# MONITORING YEAR 4 ANNUAL REPORT

## OWL'S DEN MITIGATION SITE

RE: Owl's Den Mitigation Site-Year 4 Monitoring Report  
Final Submittal for DMS  
Contract Number 004673, RFP Number 16-004110, DMS# 95360  
Yadkin River Basin – CU# 03040105; Union County, NC

Wildlands Engineering, Inc. (Wildlands) has reviewed the Division of Mitigation Services (DMS) comments and observations from the Owl's Den Mitigation Site Draft Year 4 Monitoring Report. Wildlands walked the site on 1/7/2019 to evaluate the site condition after the beaver dam was removed. Wildlands confirmed that the streams are stable and that monitoring features have not impacted by the beaver dam. The report text has been revised for the final draft to reflect the most current condition of the site. The following are Wildlands responses to your comments and observations from the report noted in italics lettering.

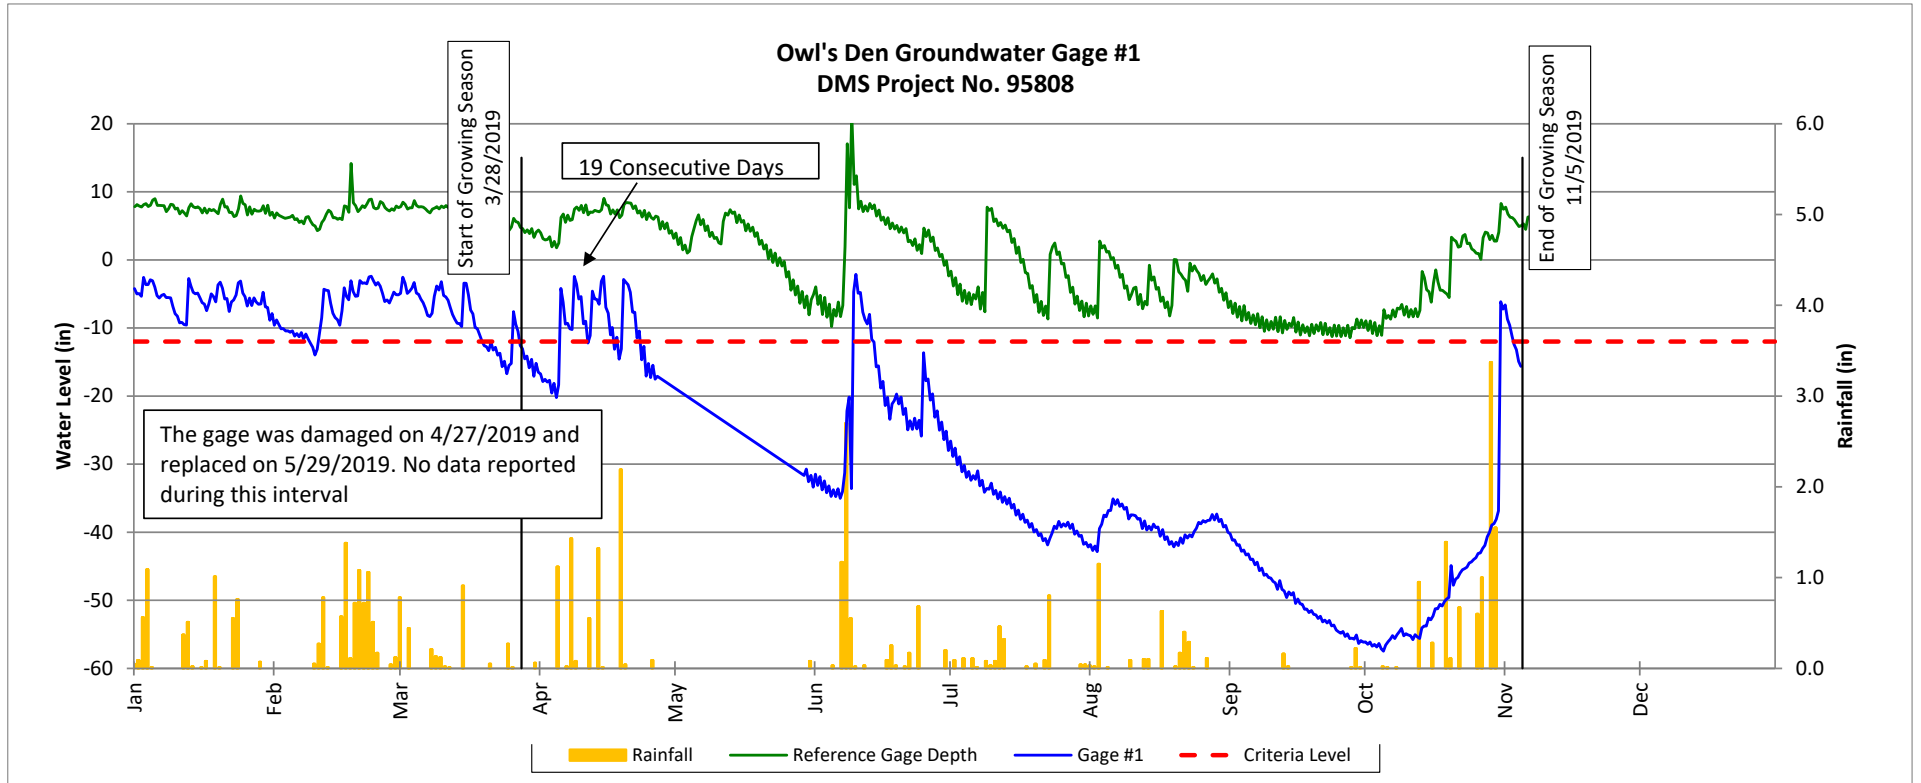
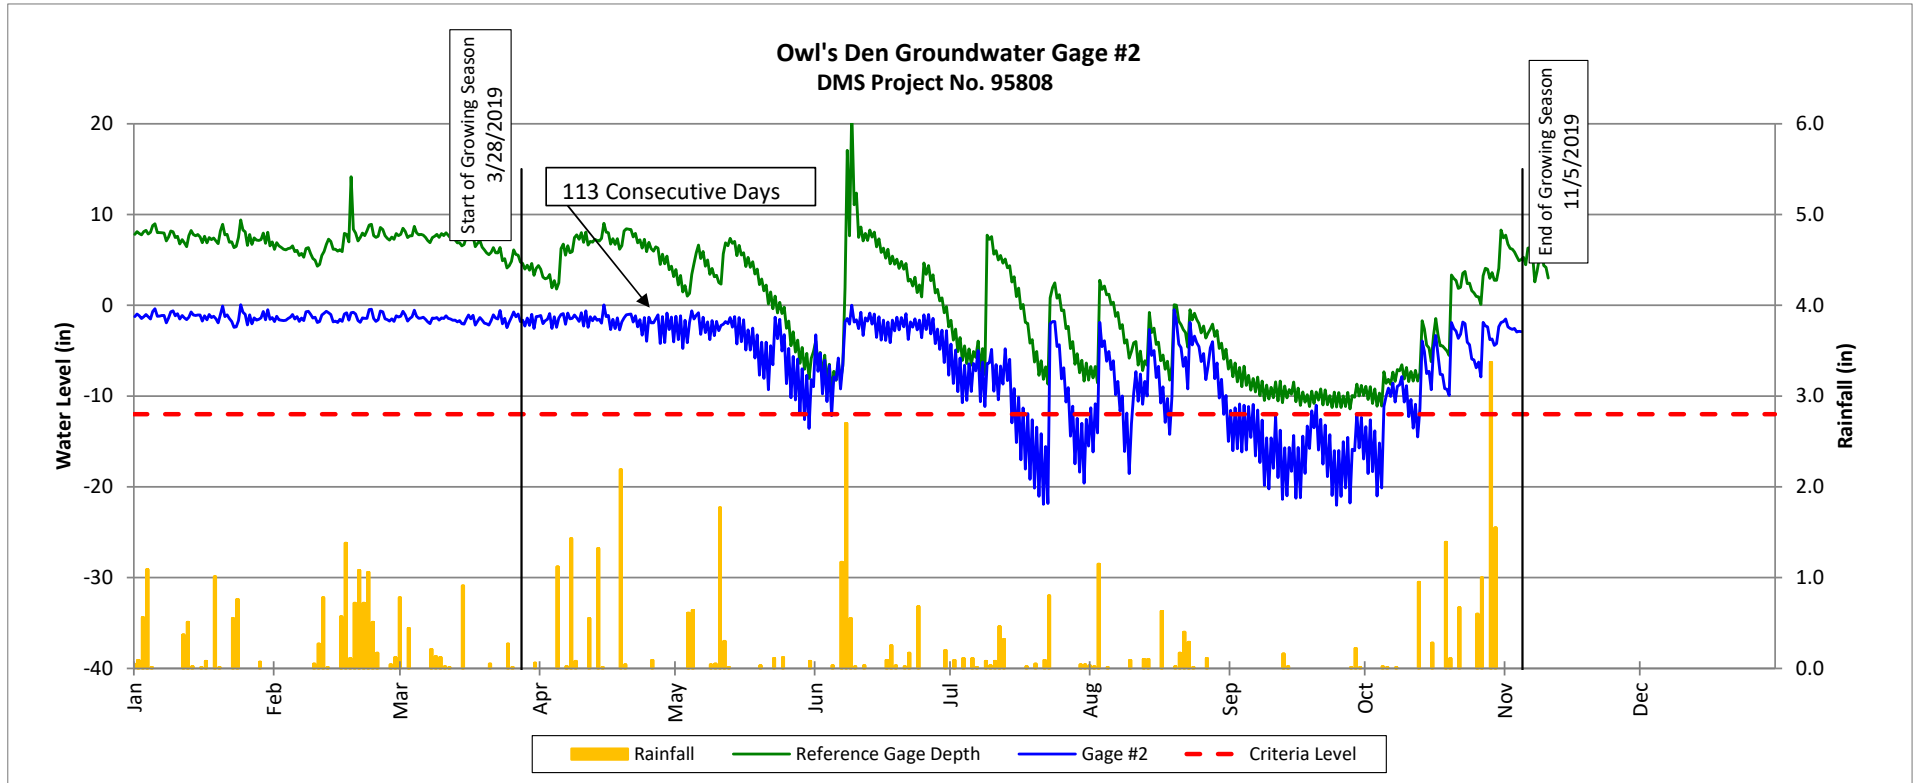
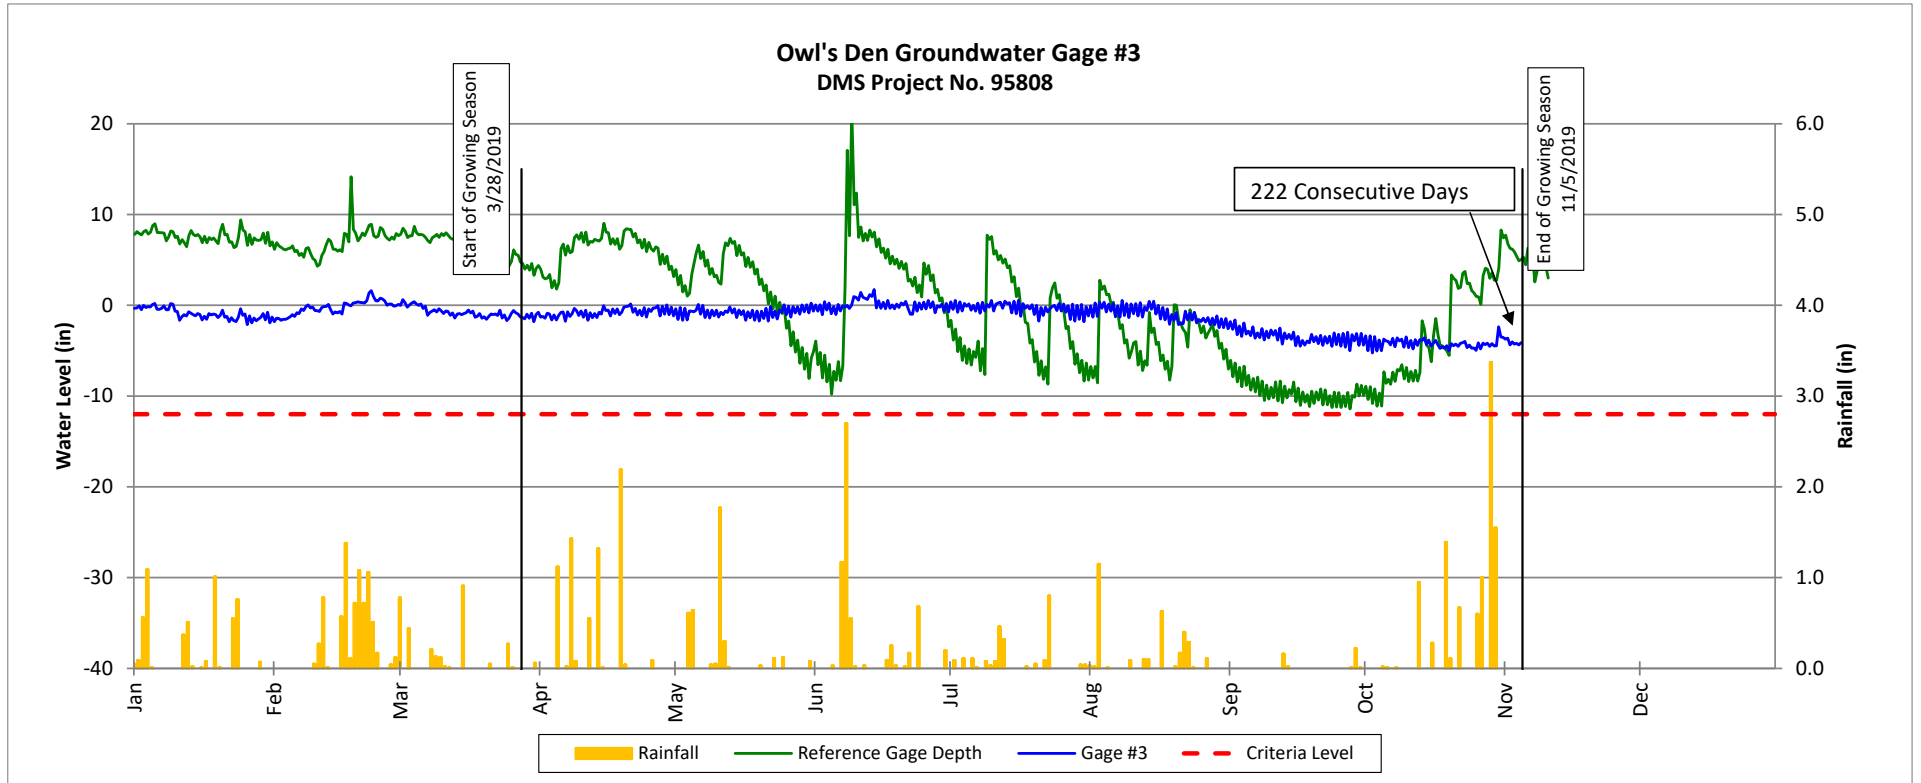
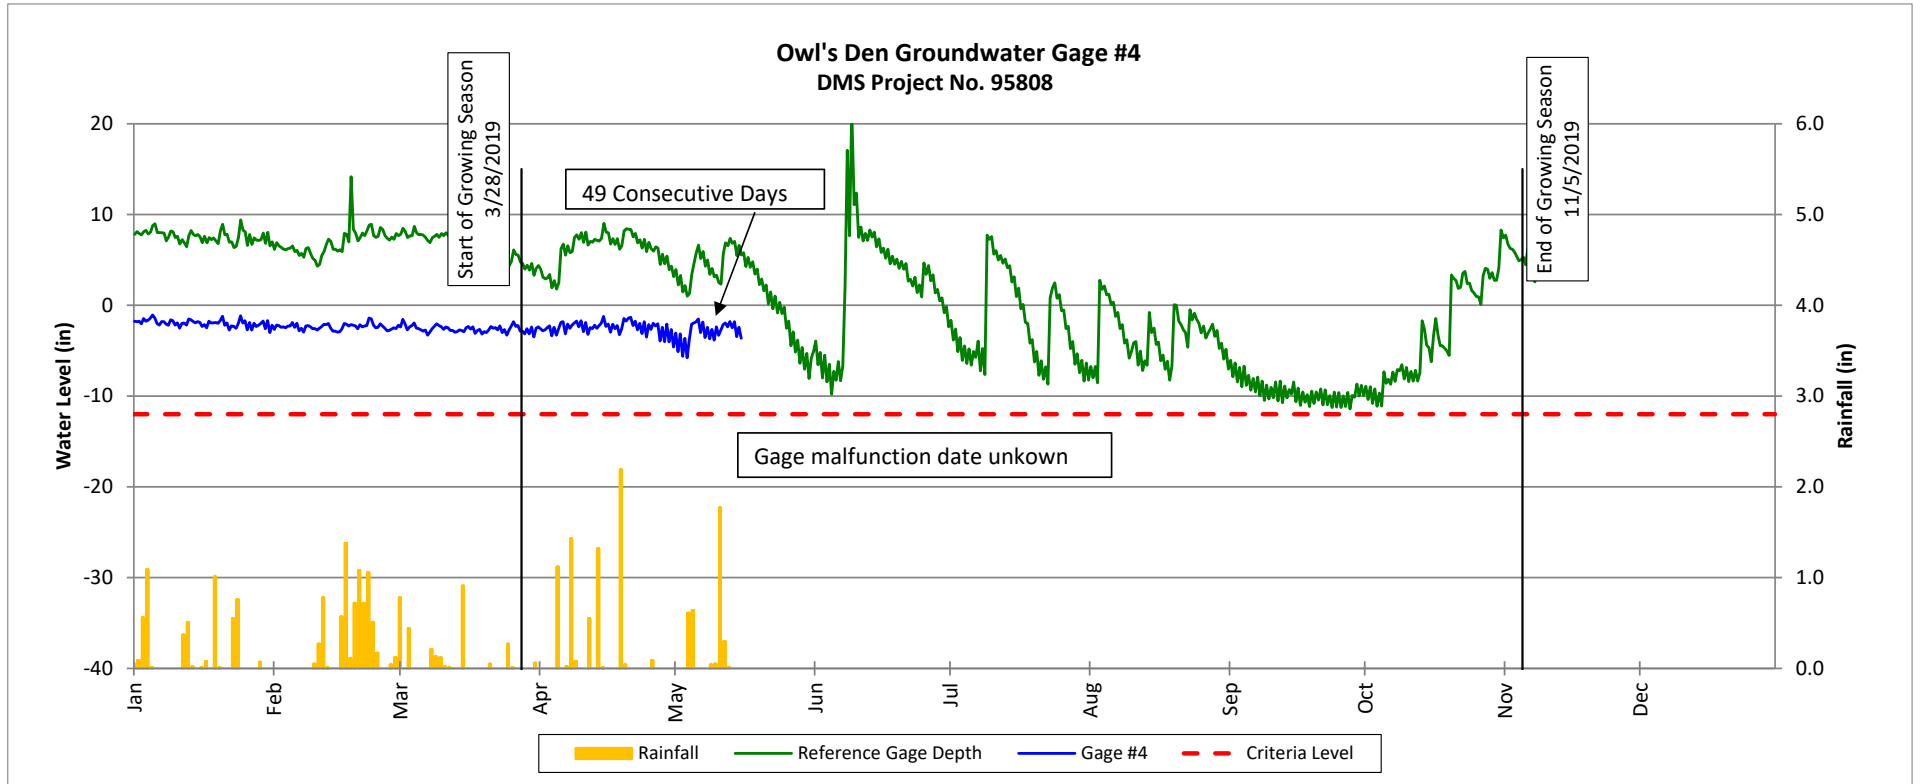
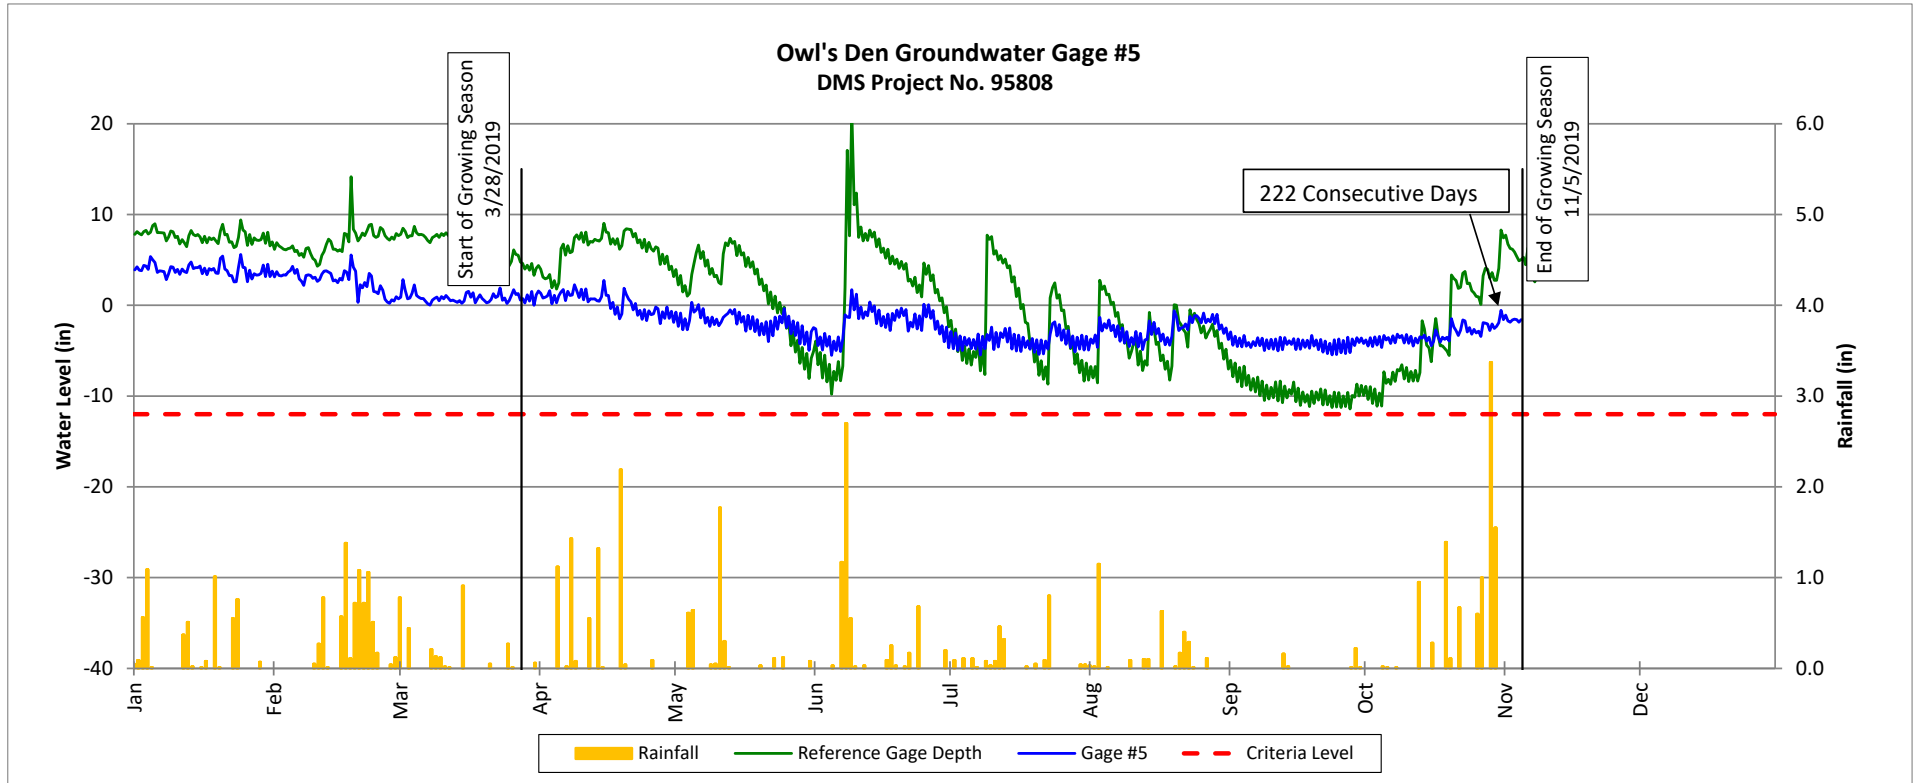
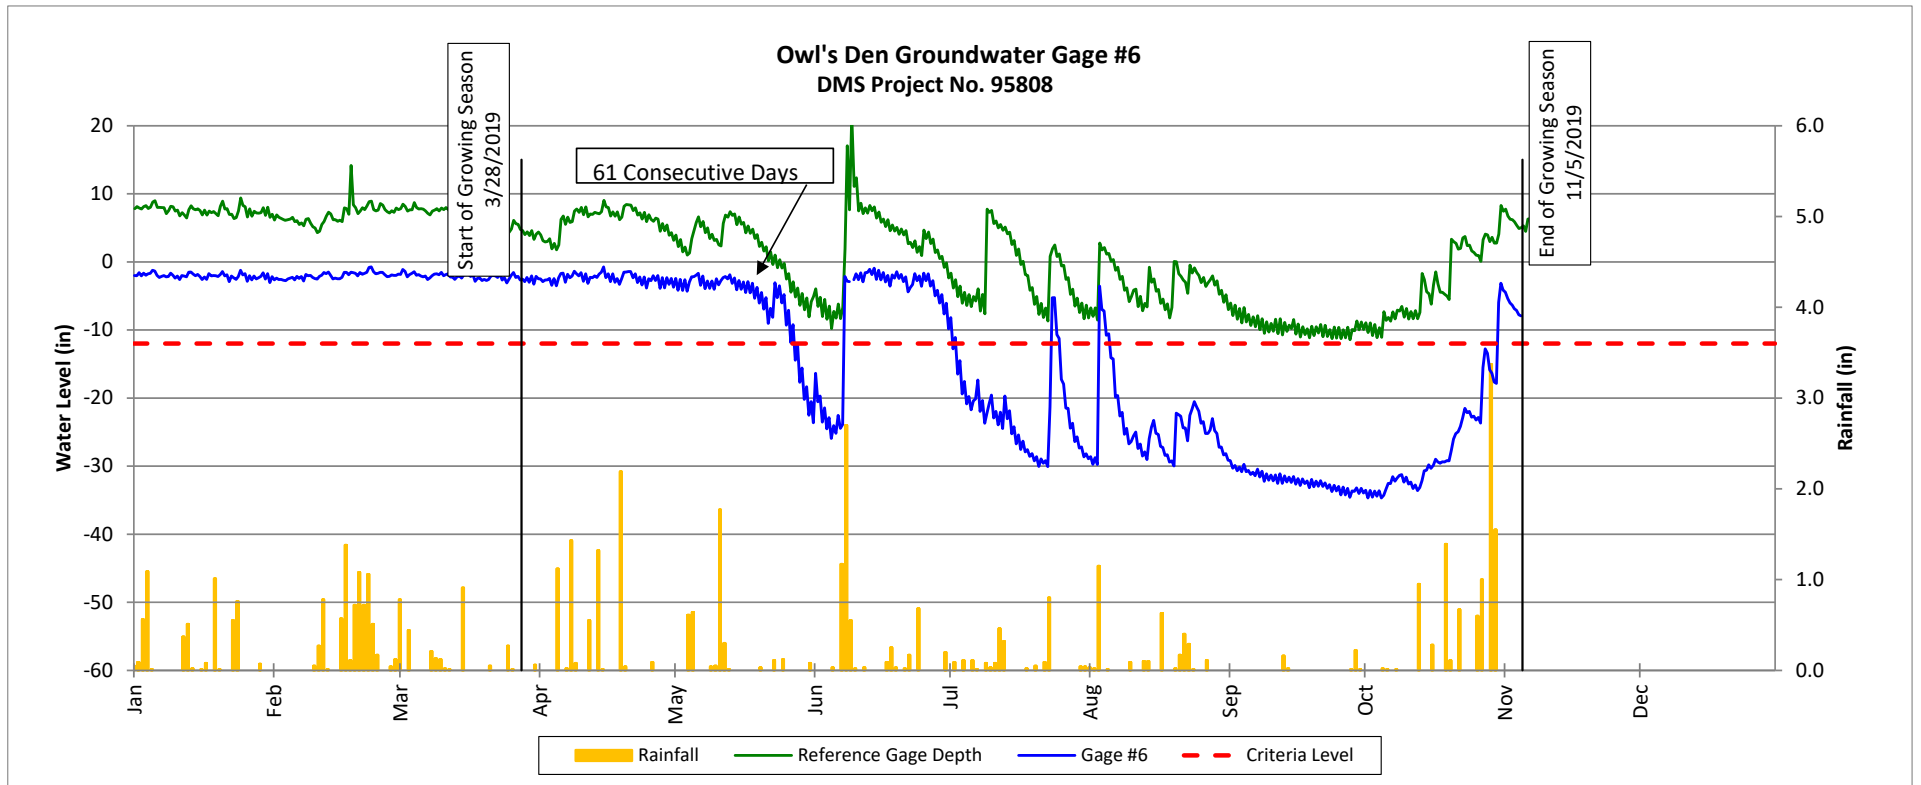
**DMS Comment; Groundwater gage plots: For clarity, consider adding the consecutive day number for each gage on the groundwater gage plots instead of using the currently shown 18-day bar. The 18-day bar adds some confusion to the plots without a description of what it corresponds to (8.1% of the growing season).**

*Wildlands Response; The consecutive number of days meeting criteria was added to each groundwater gage plot and the 18-day bar was removed.*
